**Addendum 4**  
**Solicitation 23-AA07**  
**Duluth Coastal Infrastructure Rehabilitation Project**

**Re: Duluth Coastal Infrastructure Rehabilitation – Addendum #4**

AMI Project # 211016

SHEET:  
**CT405**

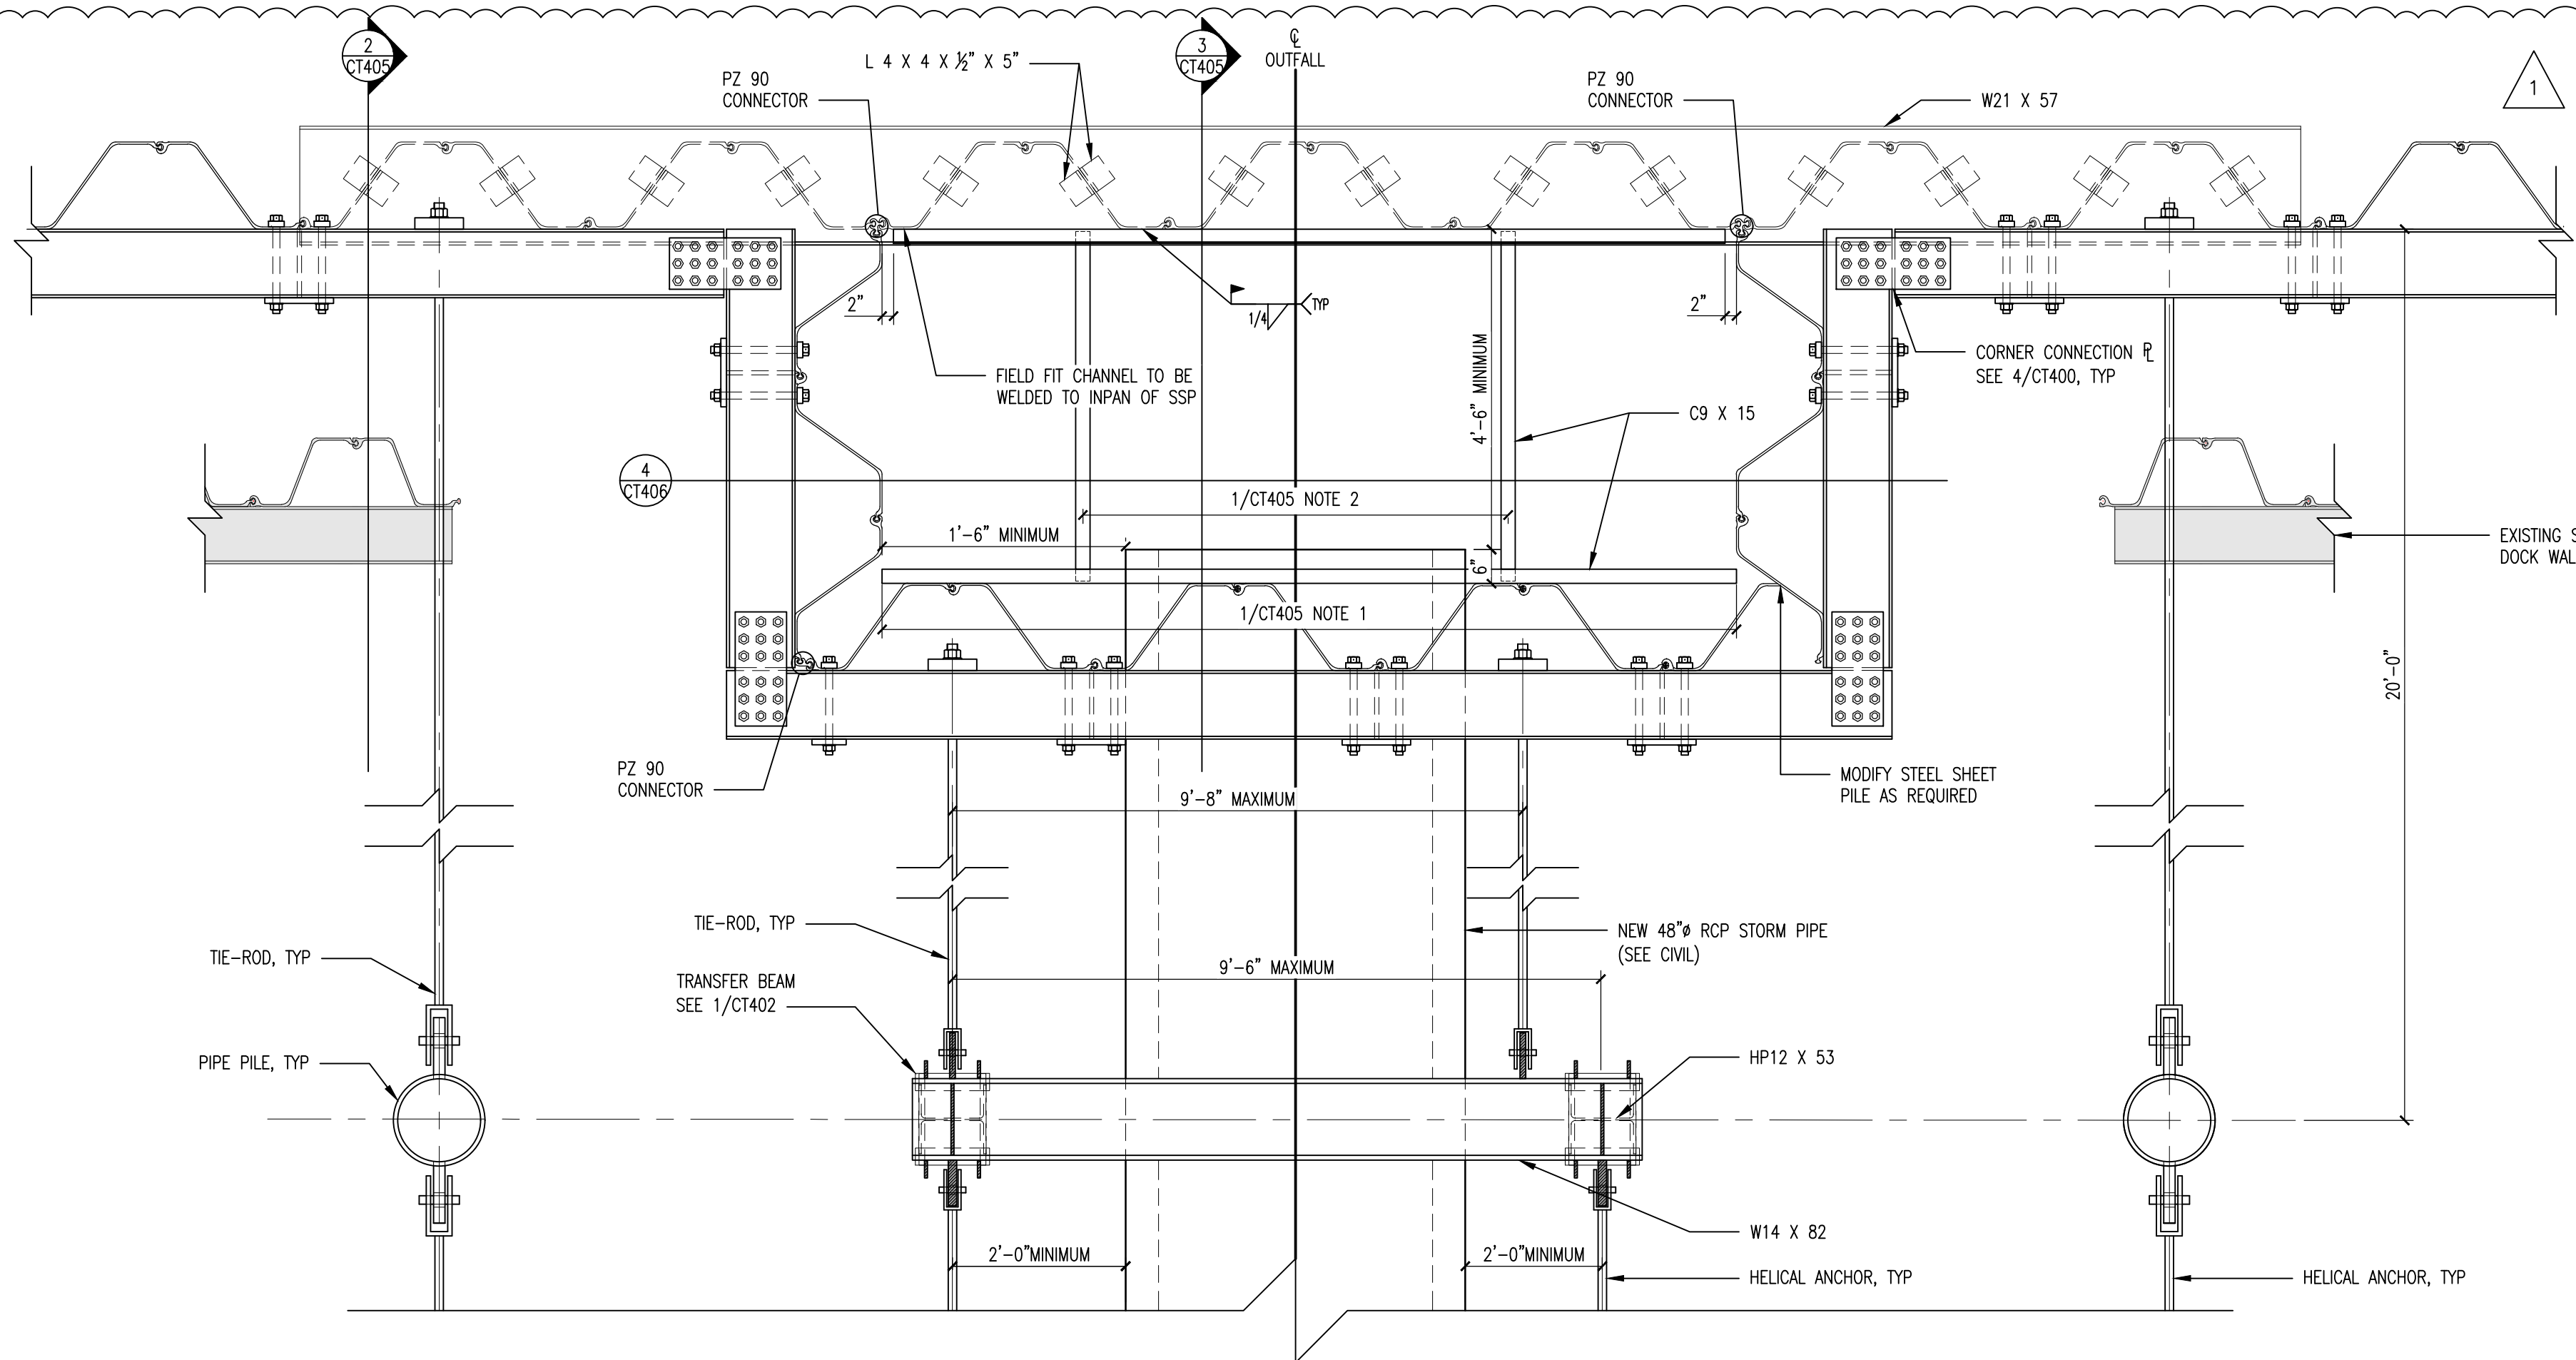
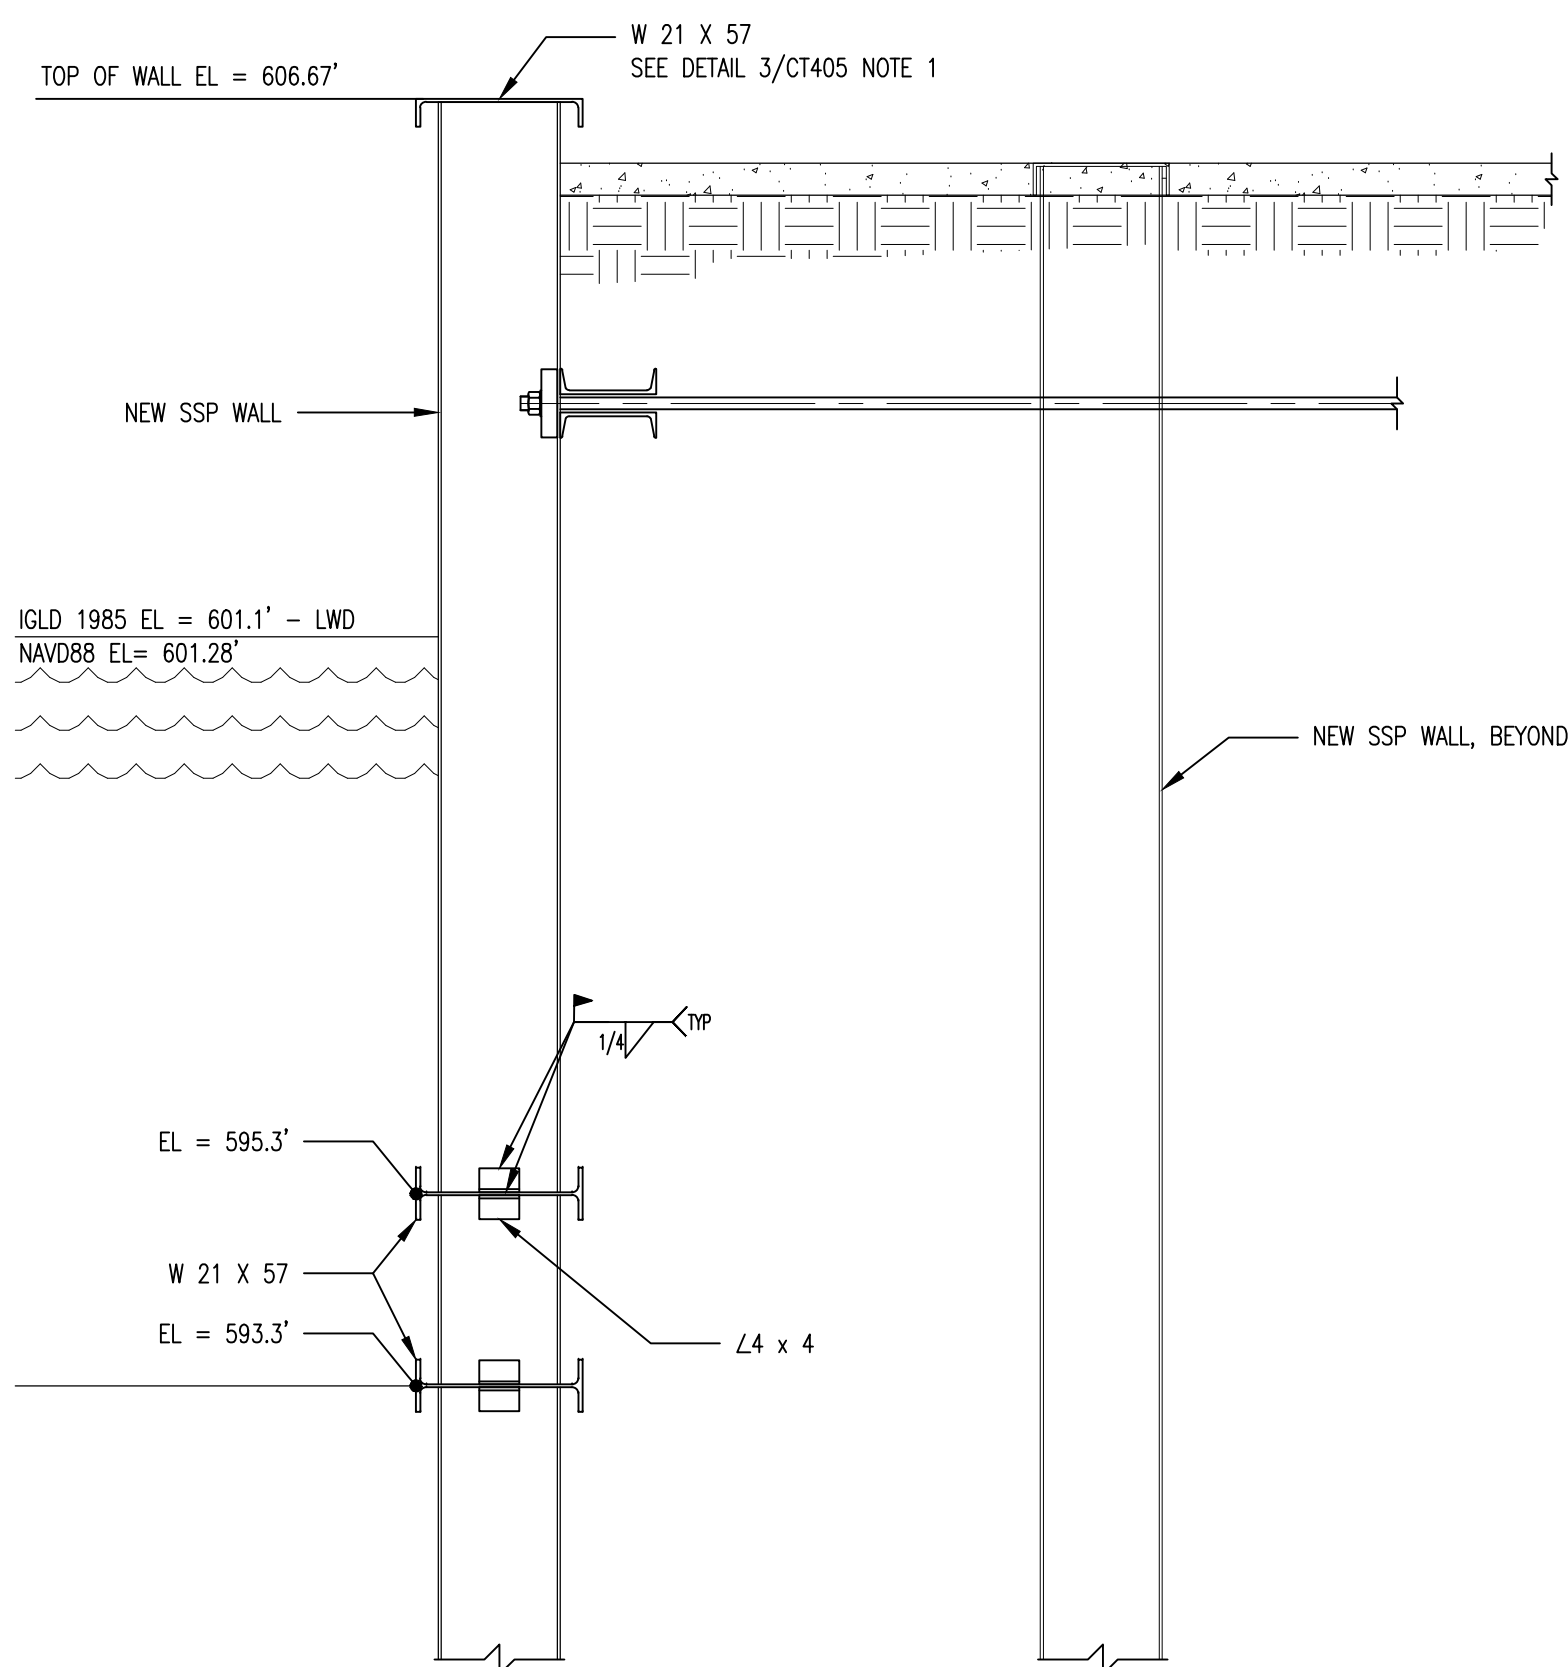
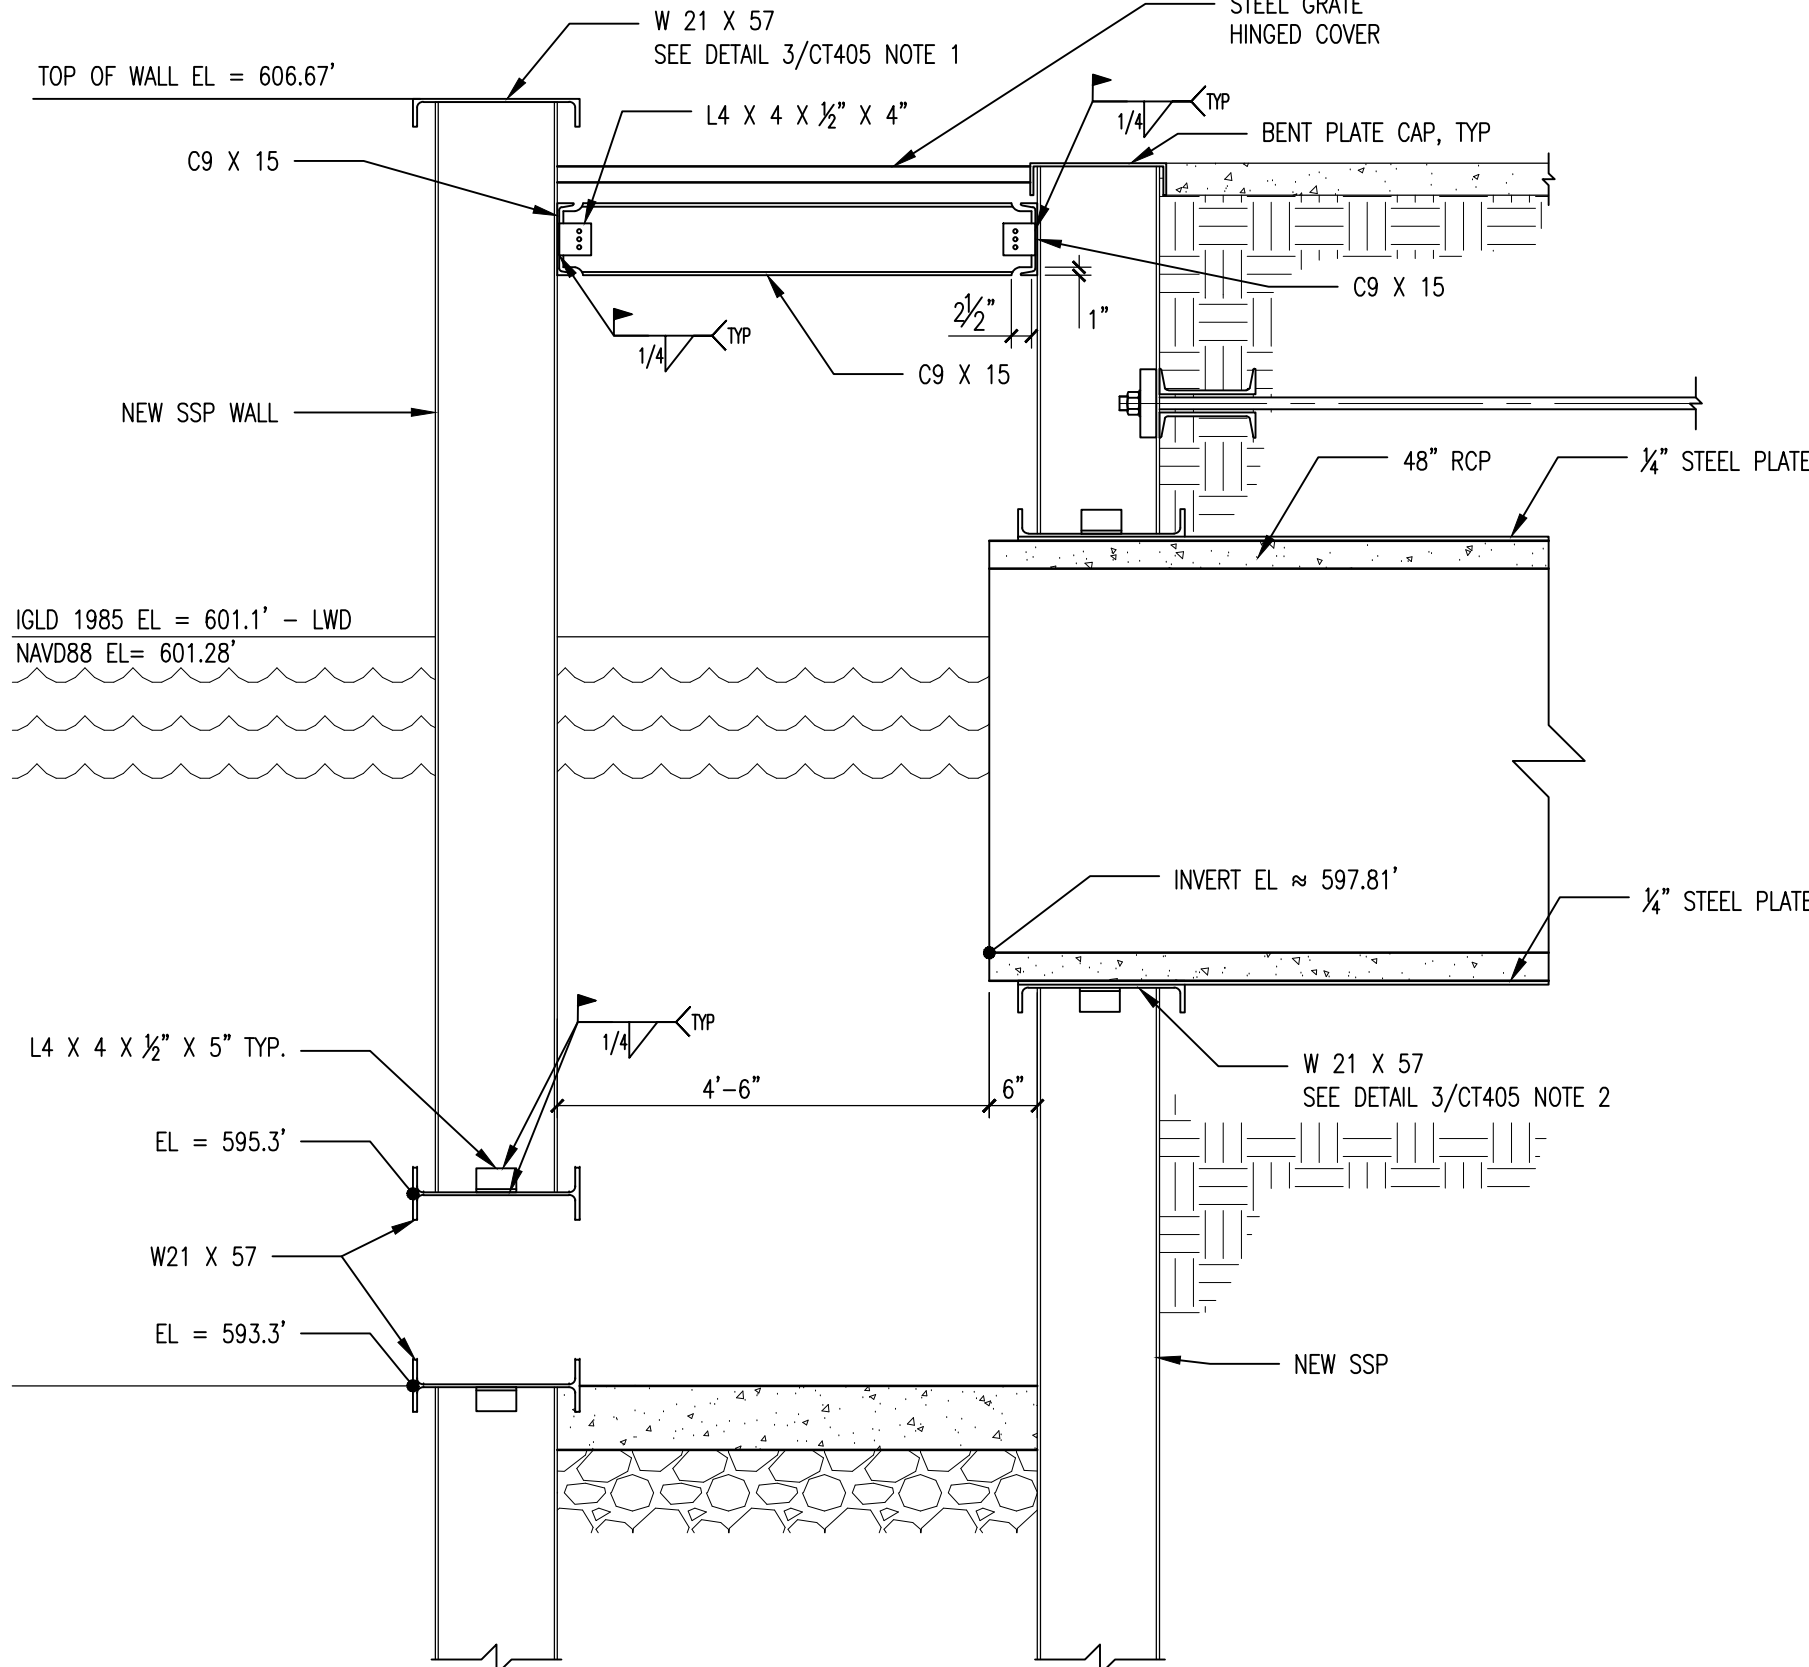
*Please provide weld details and side details at the SSP/connect at alcove per Detail 3/CT405.*

*Are there any more detailed drawings of the alcove opening pertaining to the written descriptions? What is the intent of the sheet pile cutoff and reuse?*

*Drawing 3/CT405, are there any more details on the steel grate hinged cover?*

The updated alcove detail sheets are included in this addendum.

Updated drawings for the alcove sheets no. CT/405 and CT/406 are included in this addendum. The intent of the sheet pile cutoff and reuse is to install the wide flange beam that will support the SSP on the water side.

The design of the steel grate hinged cover on drawing 3/CT405 will be Contractor’s responsibility. Updated plan sheets for CT405 and CT406 are included in this addendum to provide bidders with a level of expectations and may be altered as necessary by the Contractor. Contractor shall submit drawings and calculations signed by a Professional Engineer in the State of Minnesota for review & approval.

## Gorilla 012

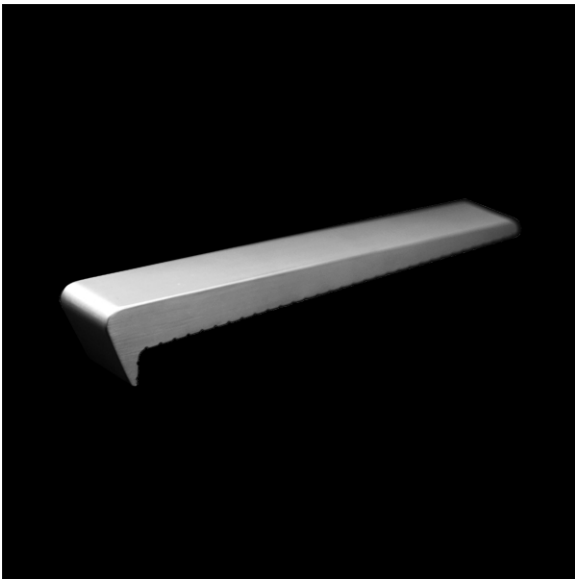
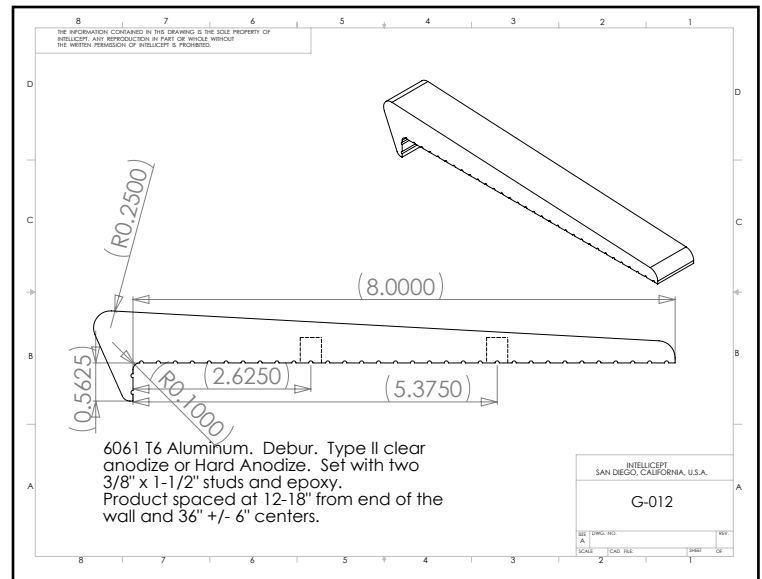
*We talked to skate stopper and the product specified is not something they make; can you clarify the product desired?*

The information is included in the *wall detail* SKATESTOPPER GORILLA012 in Clear Anodize. The product data sheet is attached to this addendum. The updated specifications are included in this addendum.
